SITE PLAN

SOIL/SITE EVALUATION
for ON-SITE WASTEWATER SYSTEM

IMPROVEMENT PERMIT DENIAL

Re: Application for Improvement Permit for property located at 4509 WOODLAND AV , MINT HILL, NC 28227
Parcel No.: 13711270
Health Department File No.: SP26-097

PROPOSED PLOT PLAN

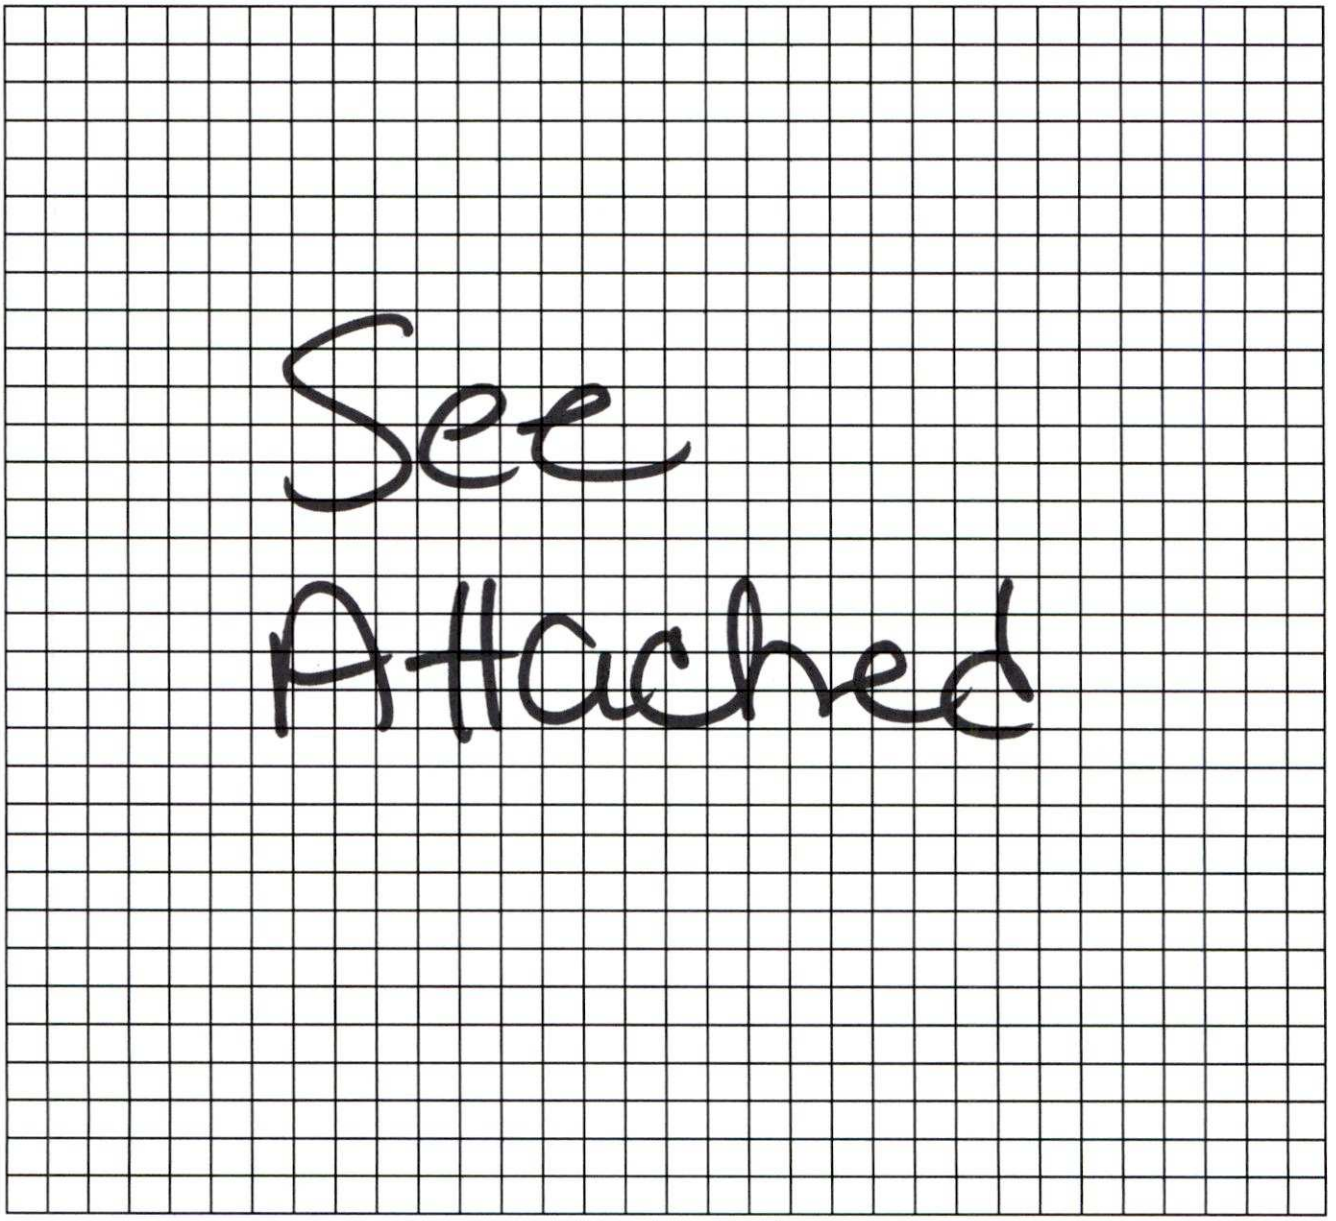
COMMENTS: There is insufficient space for a 5 BR SFR initial system and repair area with a design LTAR of 0.30.

Based on the criteria set out in 15A NCAC 18E .0501 through .0602, the evaluation indicated that the site is **UNSUITABLE** for an on-site wastewater system. Therefore, we must deny your request for an Improvement Permit. A copy of the site evaluation is enclosed. The site is unsuitable based on the following:

The site evaluation included consideration of possible site modifications, as well as use of all possible systems approved under 15A NCAC 18E. However, the Health Department has determined that none of the above options will overcome the severe conditions on this site. A possible option might be a system designed to dispose of sewage to another area of suitable soil such as off-site to additional property.

A site classified as UNSUITABLE may be classified as SUITABLE if written documentation is provided that meets the requirements of Rule .0509(b) or (c). A copy of this rule is enclosed. You may hire a consultant to assist you if you wish to try to develop a plan under which your site could be reclassified as SUITABLE.
